Authorized Field Change

AFC G-01904

Subject: Revision to the Grille to Hood Attachment to Prevent Grille Stress Cracks on 4300 and 4400 Models Built Between October 24, 2000 and April 11, 2001

Figure 1 Grille Installation

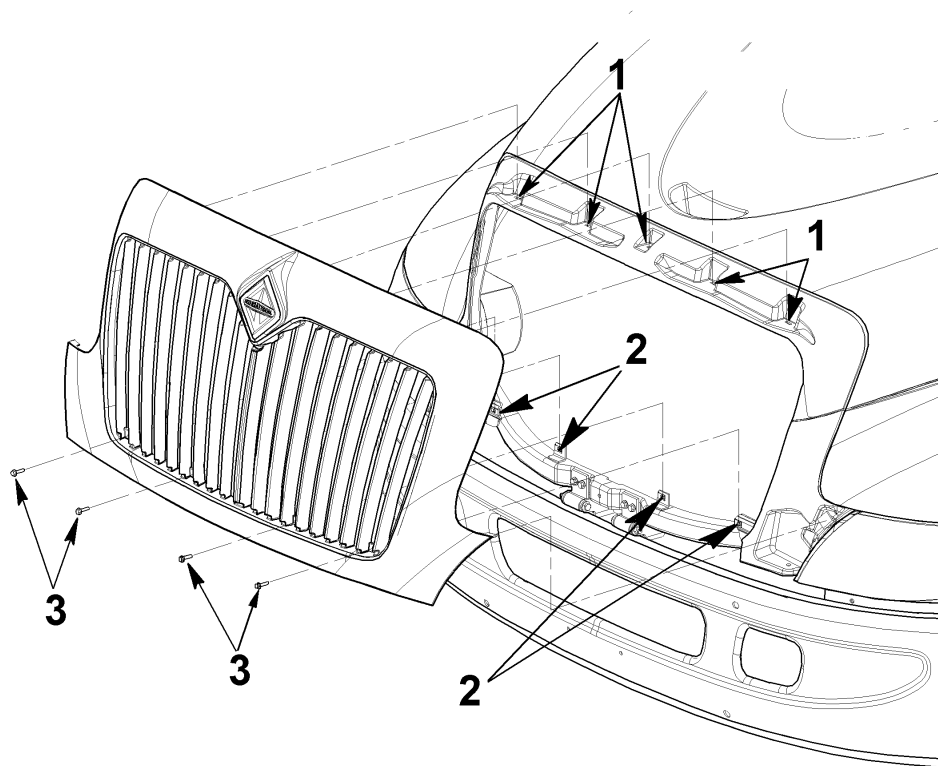
4300 and 4400 Models built between October 24, 2000 and April 11, 2001 may develop grille stress cracks at both the upper and lower attachment points. This service procedure revises the grille attachment method and isolates the grille to prevent cracking.

1. Remove the four grille mounting bolts (Figure 1, Item 3).
2. Remove grille by lifting the grille up and outward from the mounting tabs (Figure 1, Item 1). Set the grille aside for re-installation.
3. Enlarge the lower grille mounting holes (Figure 1, Item 2) to 0.5 inch diameter.
4. Install four well-nuts, from Kit Part Number 8000823R91, into the lower grille mounting holes. The well-nut flange must be flush against the mounting hole surface.
5. Install the grille with four new mounting bolts from kit Part Number 8000823R91. Tighten until snug.
